PITTSFIELD ER BRF 022-1(23)
CONTRACTOR FABRICATED PRE-CAST

- SHEET1: ABUTMENT #1 PLAN
- SHEET2: ABUTMENT #2 PLAN
- SHEET3: WING WALL PLAN
- SHEET4: ABUTMENT CASTING PLAN
- SHEET5: GENERAL NOTES
- SHEET6: QC PROCEDURES/PLAN
- SHEET7: POST TENSIONING DETAILS
- SHEET8: POST TENSIONING DETAILS
- SHEET9: CONCRETE MIX DESIGN

Vermont Agency of Transportation
RECEIVED
CK'D BY JG OK'D BY WL
March 17, 2014
RESUBMIT YES Rejected
BY KH DATE 4-1-2014

COLD RIVER BRIDGES, LLC 10 LANBRO LANE WALPOLE, NH TEL 603-756-9300 FAX 603-756-9303	
PITTSFIELD ER BRF 022-1(23)	
ABUT 1 PLAN/ELEV	SHEET NUMBER 1
DATE: 1-17-14	scale: 1/4"=1'

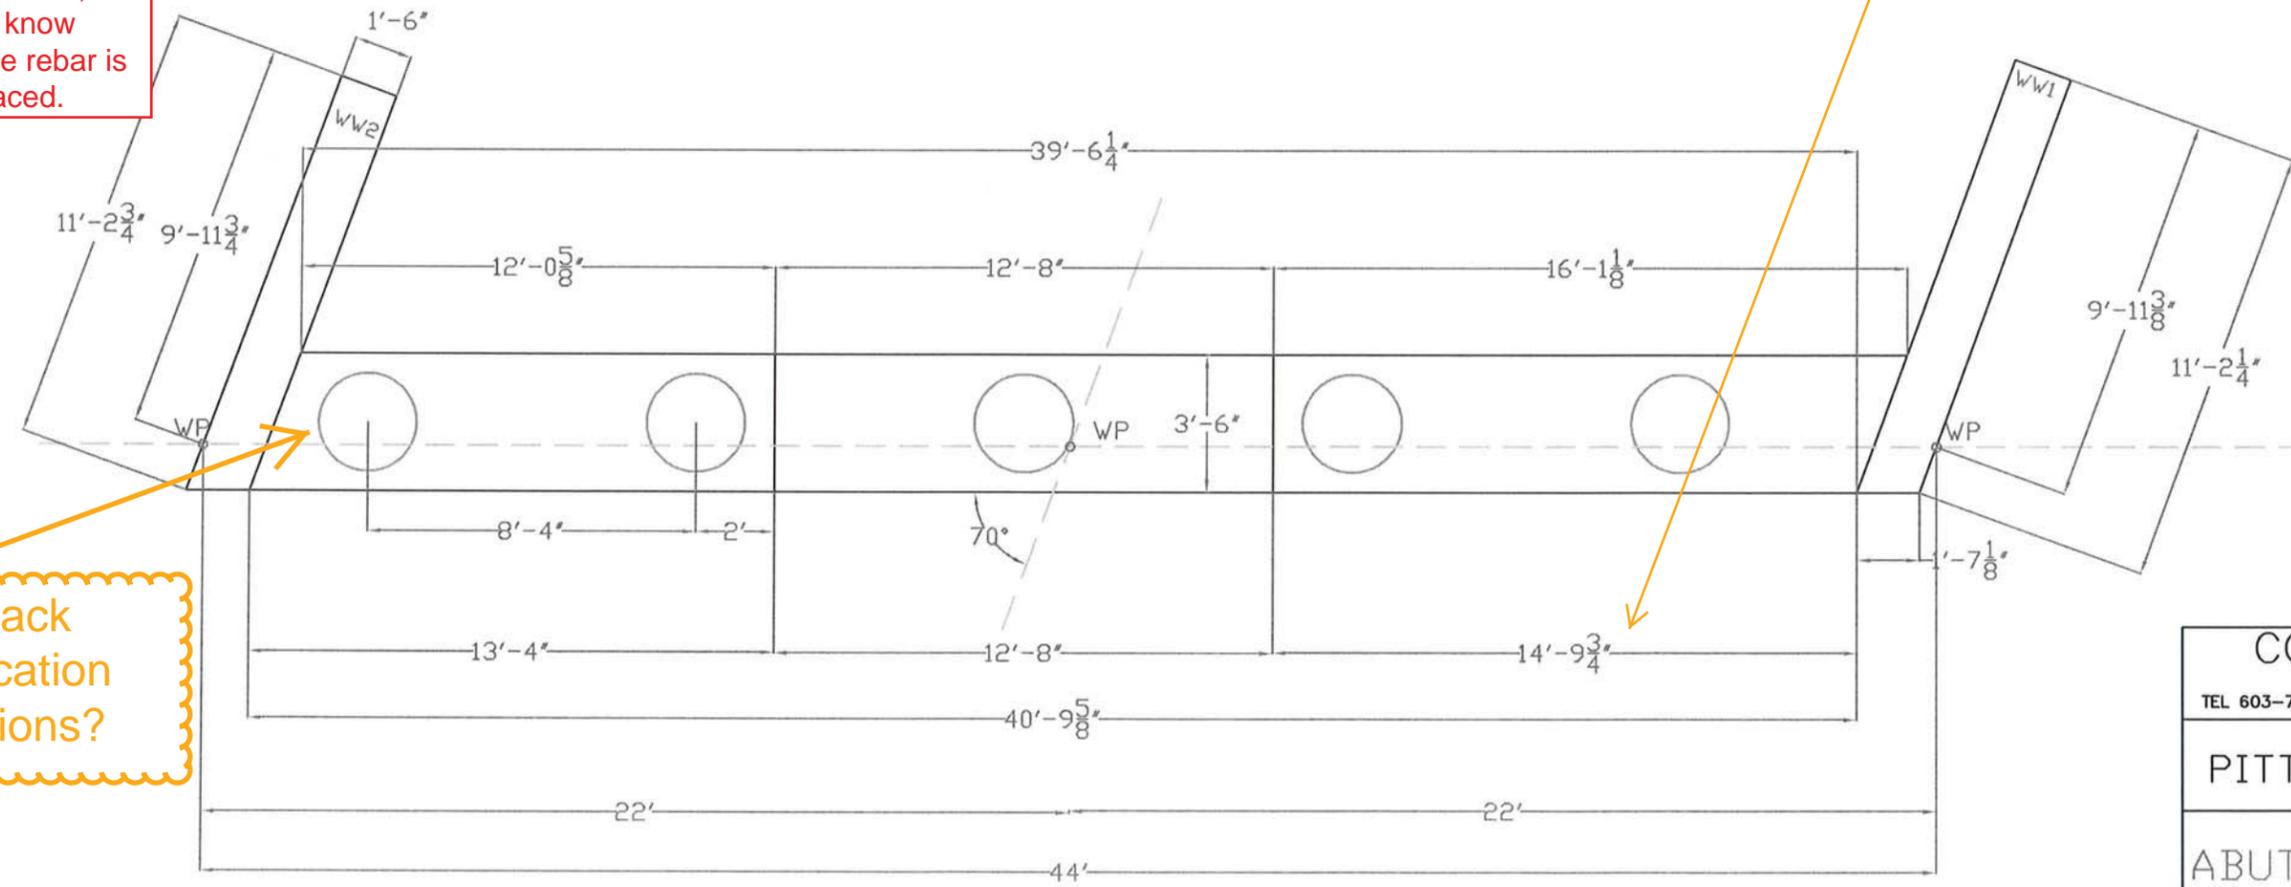
What is the extent of the the slope on the bridge seat?

Please show WW1 and WW 2 Height and Elevations

Are these elevations carried out to the edge of the wing walls or to the edge of the original "cheekwall"? As that would differ from the elevations given in contract plans

Please detail lifting points in abutments

Please detail rebar in a side elevation view. No cover is mentioned in the steel schedule, so we don't know where the rebar is being placed.

Note: due to skew, the abutment height is different on both front and rear faces of construction joint.

Please verify location of wing wall. It does not appear to match the plan view drawing

Front/Back Pipe location dimensions?

Please show all elevations and heights at construction joints (TYP)

COLD RIVER BRIDGES, LLC 10 LANBRO LANE WALPOLE, NH TEL 603-756-9300 FAX 603-756-9303	
PITTSFIELD ER BRF 022-1(23)	
ABUT 2 PLAN/ELEV	SHEET NUMBER 2
DATE: 1-17-14	scale: 1/4"=1'

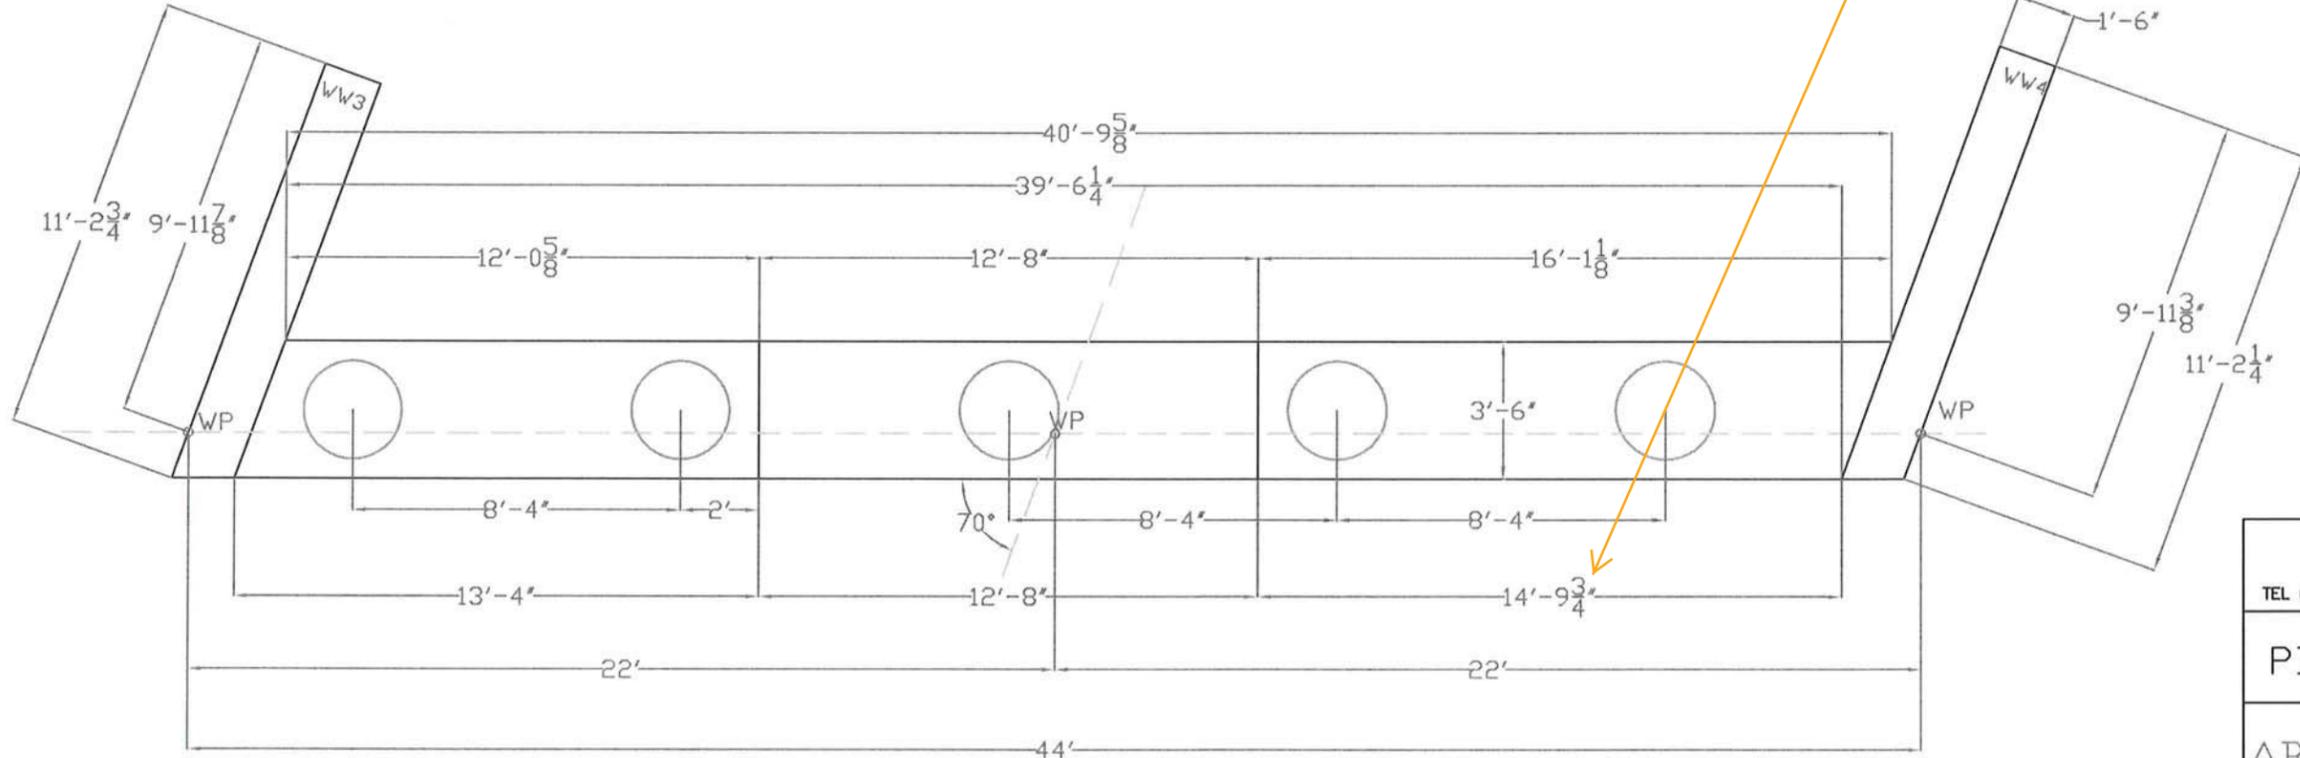
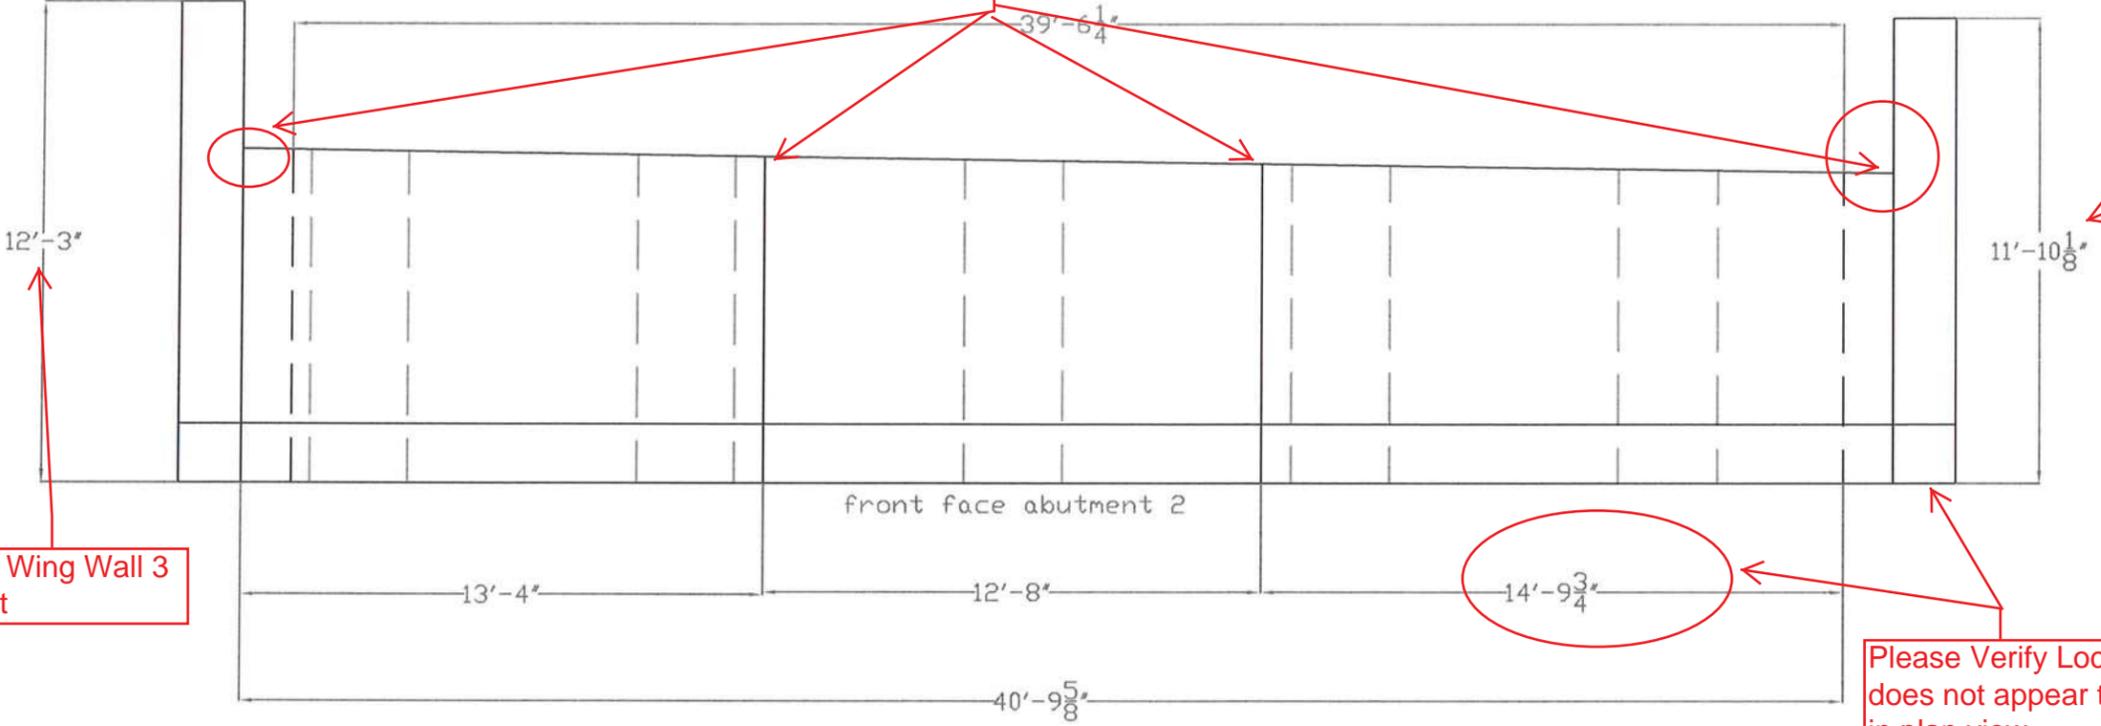
Verify Wing Wall 4 Height

Please show all Abutment 2 Heights and Elevations

Verify Wing Wall 3 Height

Please Verify Location of Wing Wall. It does not appear to match what is shown in plan view.

why not label each view?

COLD RIVER BRIDGES, LLC 10 LANBRO LANE WALPOLE, NH TEL 603-756-9300 FAX 603-756-9303	
PITTSFIELD ER BRF 022-1(23)	
WW PLAN	SHEET NUMBER 3
DATE: 1-17-14	scale: 1/4"=1'

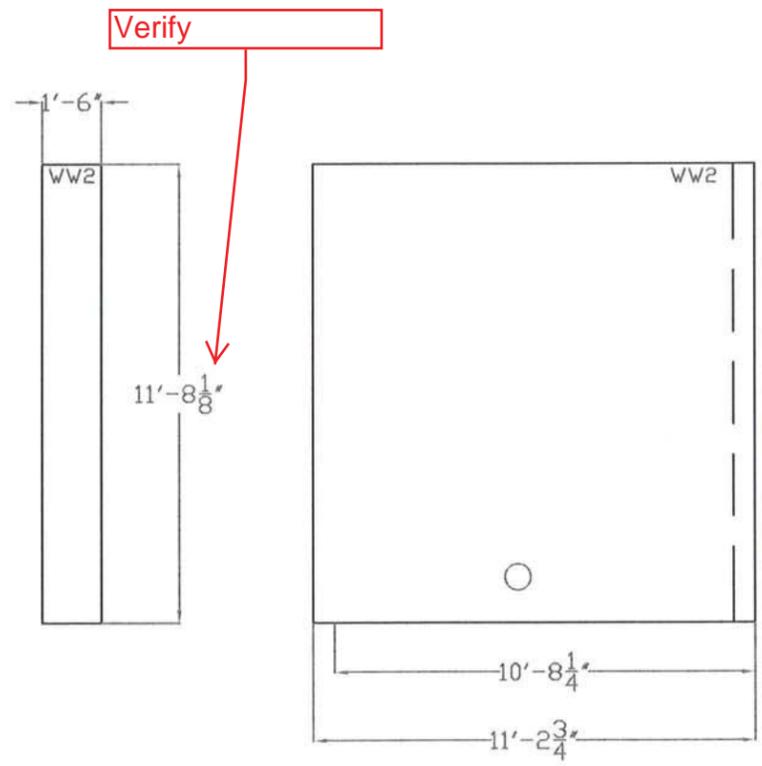
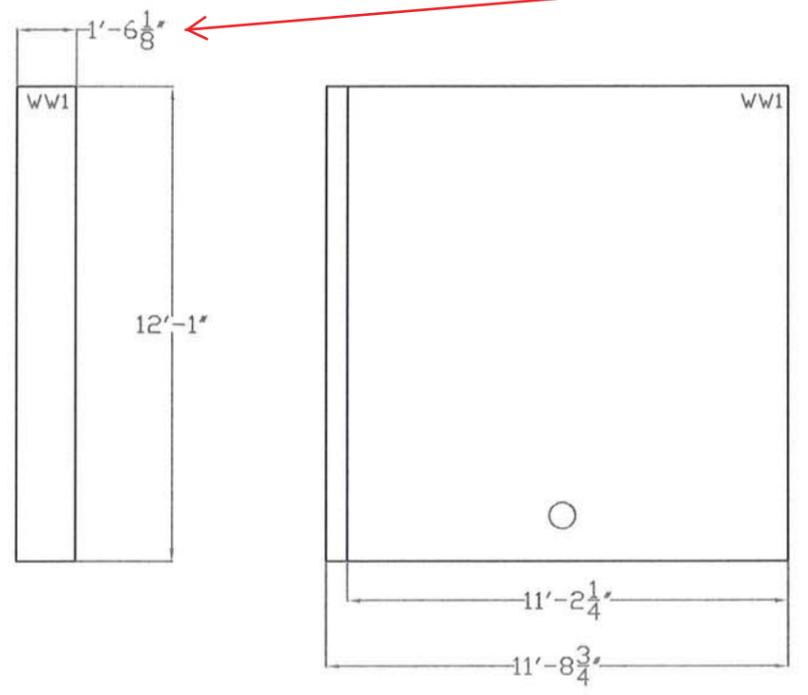
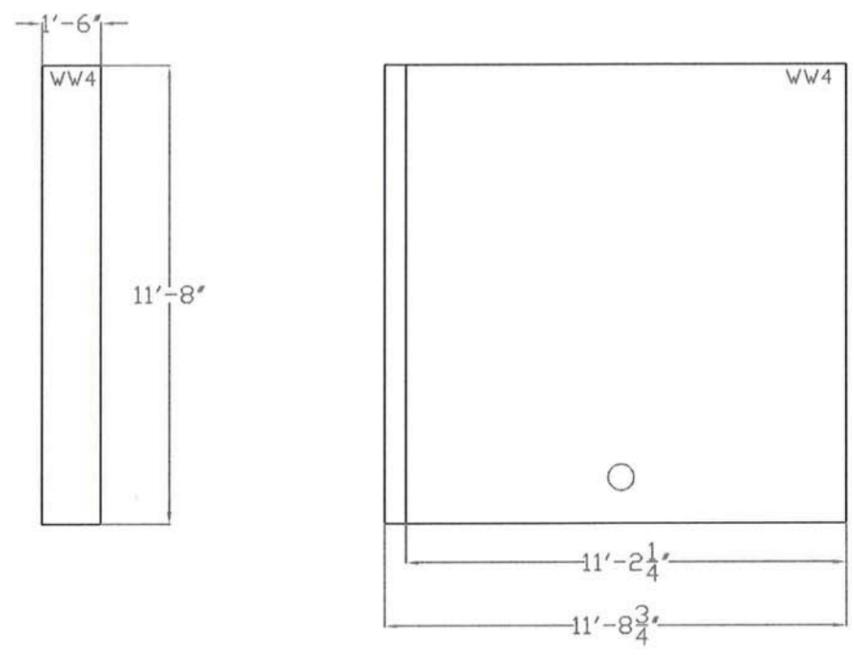
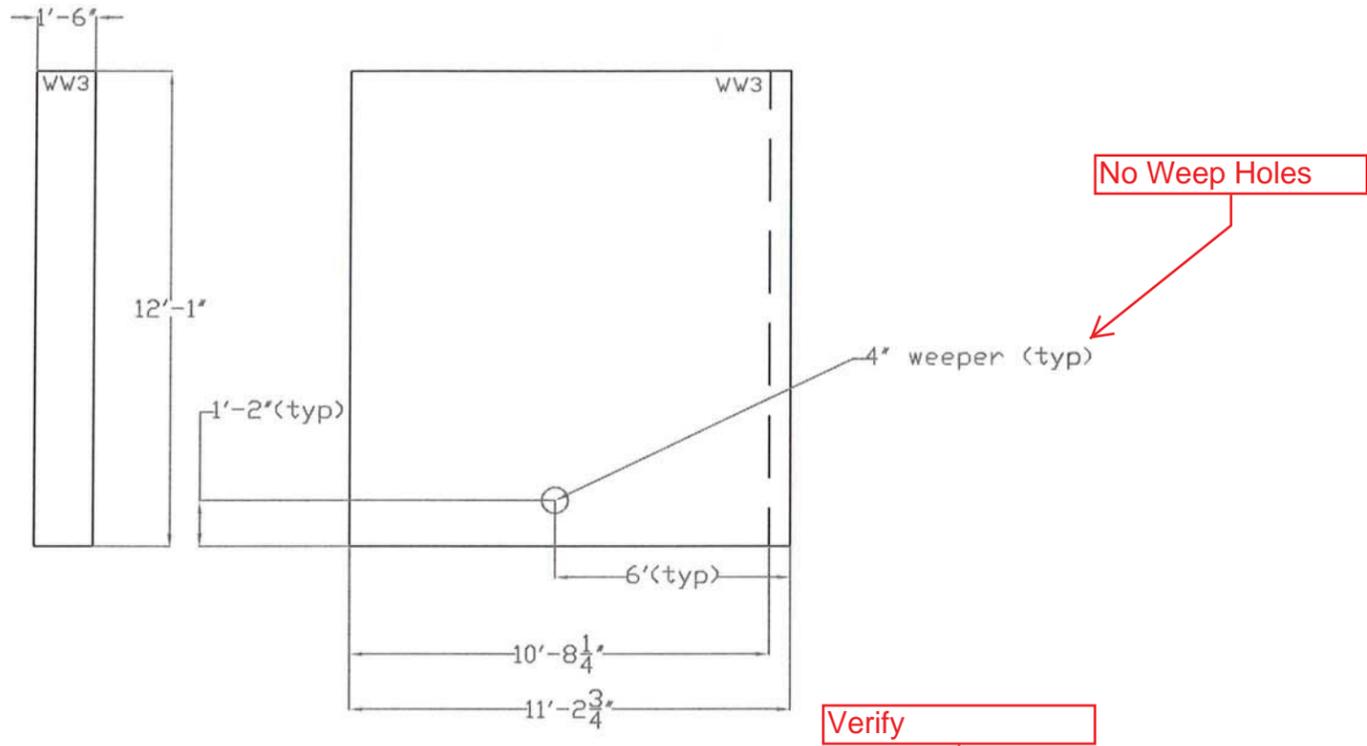
Please detail lifting points in wing walls

ABUTMENT CASTING PLAN

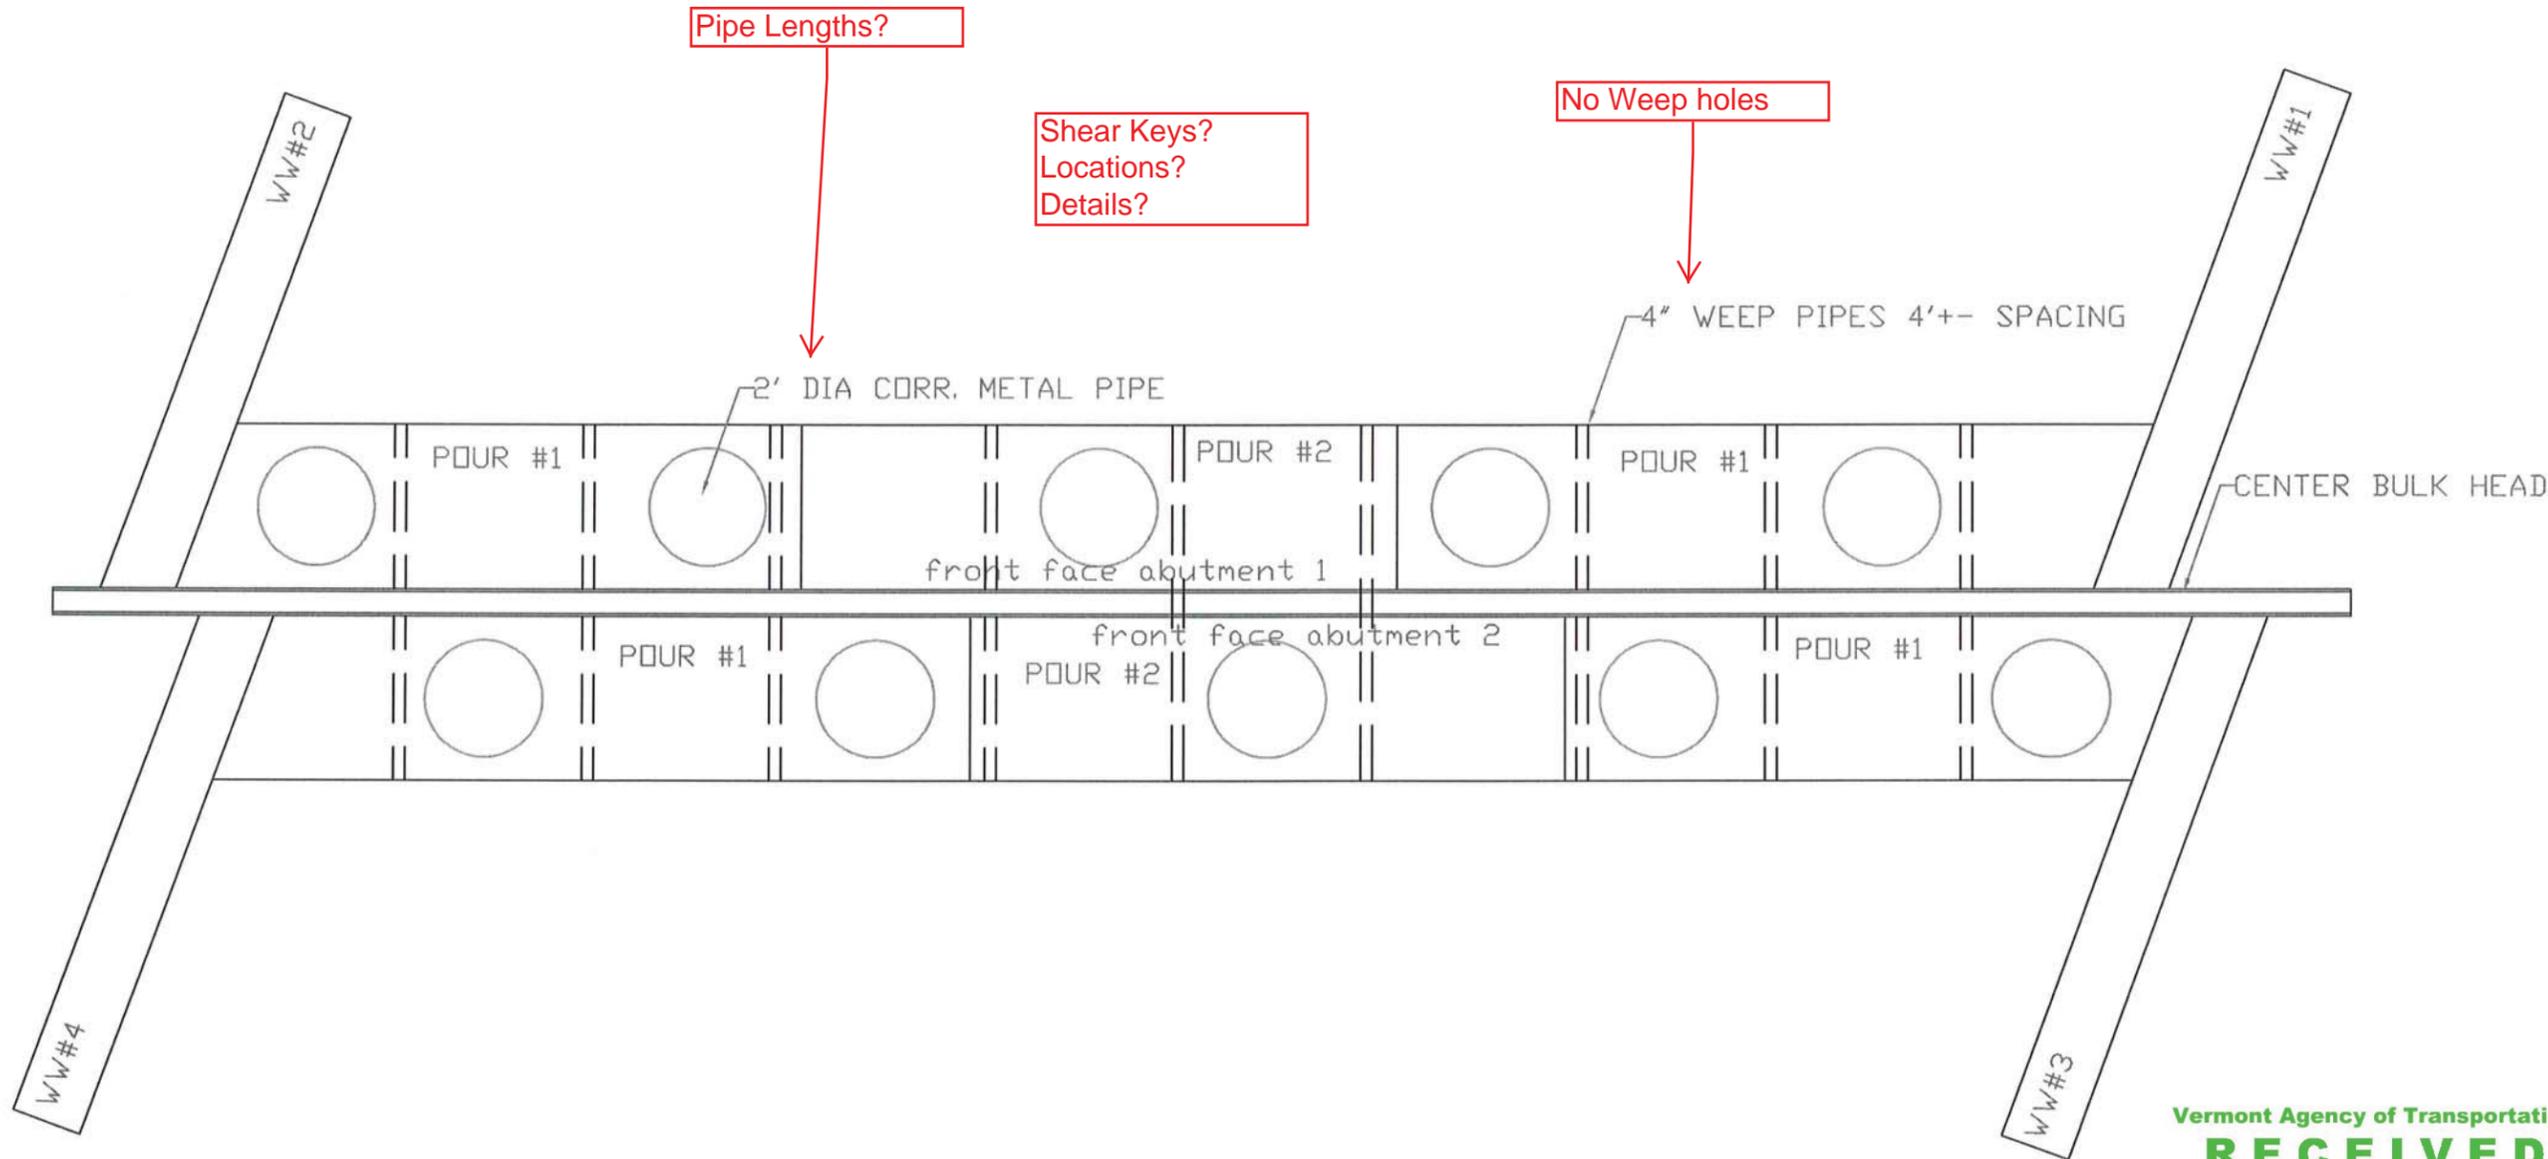
Pipe Lengths?

Shear Keys?
Locations?
Details?

No Weep holes
